Water Supply Amendment. Bowdens Silver Project.

Thank you for allowing me to respond to the amendment to the Bowdens Silver Project.

Figure 6.1
MINE SITE LAYOUT AND CATCHMENTS

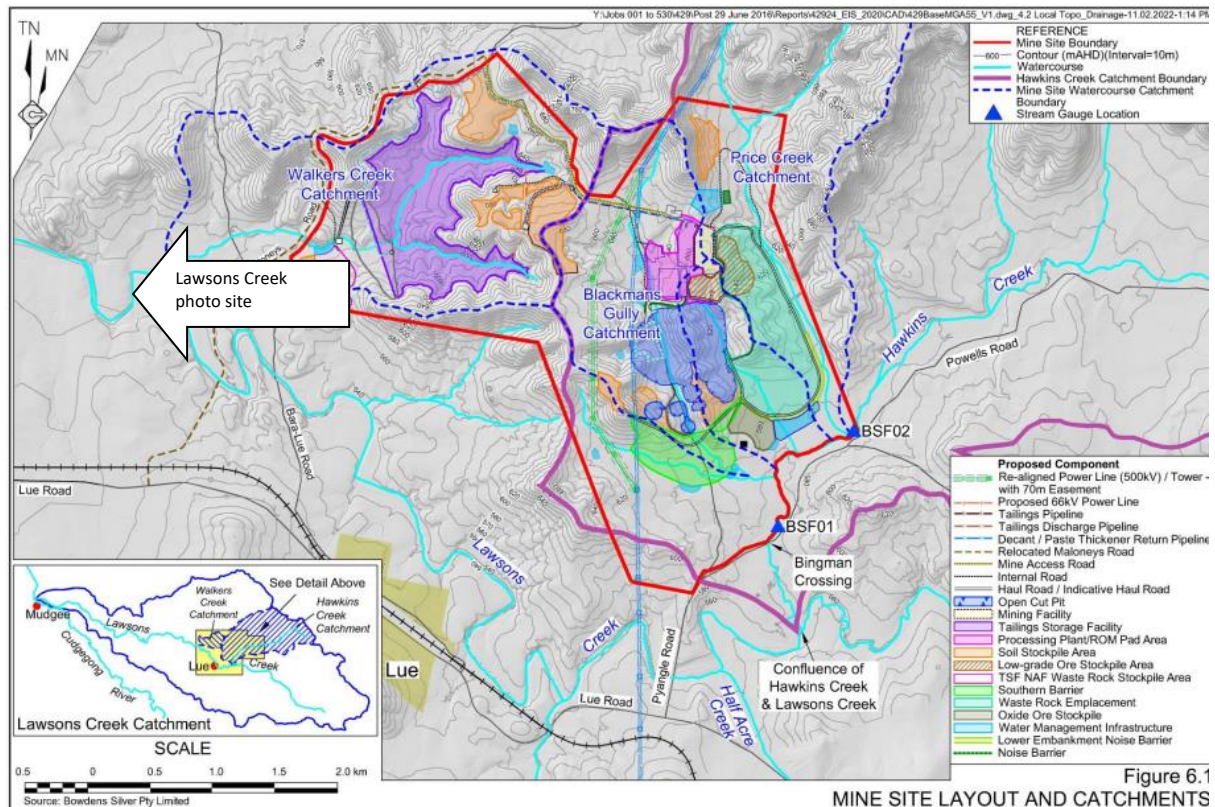
Flow Rate Modeling is predicted to drop in Lawson Creek by 1.2% to 4.5% during operations. Please see attached photo of Lawsons Creek in 2019 and explain where a reduction of 4.5% comes from? I would like to see Bowdens reduce the flow at this time by 4.5% and find 14ML of baseflow reduction.

The arrow on the map below indicates the location of Figures 1,2 and 3.

This truly demonstrates the Projects inability to secure a reliable water source.
